Informal document GRSP-54-07-Rev.1
(54th GRSP, 17 - 20 December 2013,
agenda item 3(b))

**Proposal for Amendment [2] to global technical regulation
No. 9 (Pedestrian safety)**

**Proposal of amendment to document
ECE/TRANS/WP.29/GRSP/2012/14,
Submitted by the expert from the European Commission**

"Figure 6A

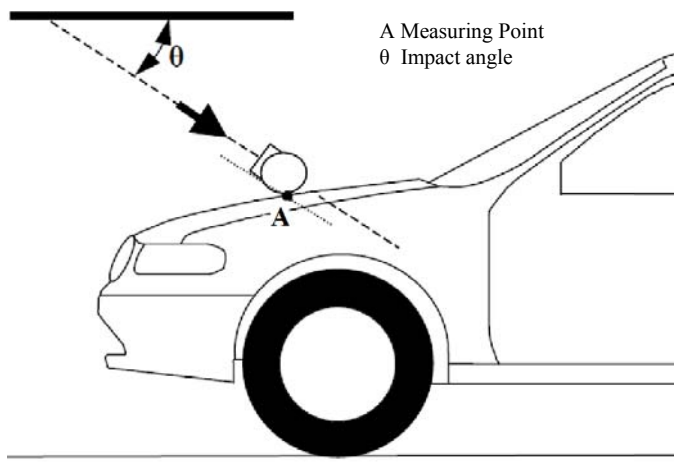
Figure 6, shall be deleted

Insert new Figures 6A and 6B, to read:

Measuring point in the vertical longitudinal plane through the center of the headform impactor (see paragraph 3.20.1.)²

² Remark: due to the spatial geometry of the bonnet top, the first contact may not occur in the same vertical longitudinal or transverse plane which contains measuring point A.

3.20.1. "Measuring point" for the headform test means a point on the vehicle's outer surface selected for assessment. The measuring point is where the headform's profile contacts the vehicle's outer surface cross section in a vertical longitudinal plane through the center of gravity of the headform (see Figure 6A).

"Figure 11

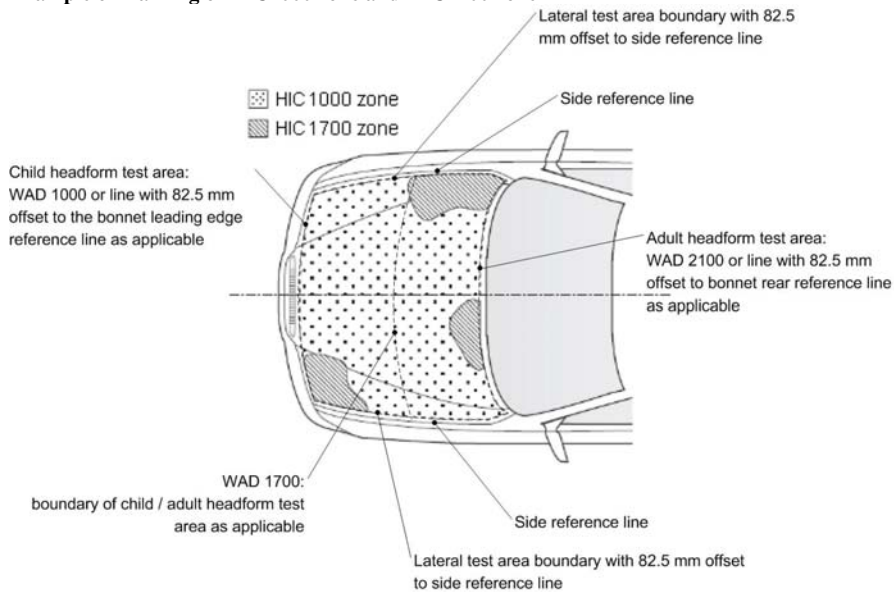
Figure 11(former), shall be deleted

Insert new Figure 11, to read:

Example of marking of HIC1000 zone and HIC1700 zone

"5.2.4.1. The manufacturer shall identify the zones of the bonnet top **test area** where the HIC must not exceed 1,000 (HIC1000 Zone) or 1,700 (HIC1700 Zone) (see Figure 11)."
